3D top side

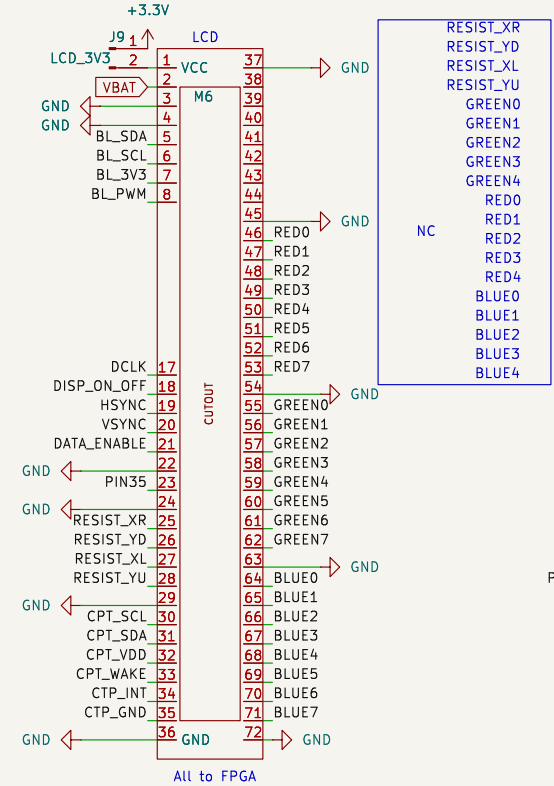
Why on earth are A1 and B1 connected to two different PMQDs, when there are unused pins on the FPGA?

Problematic - 8 9 11 12
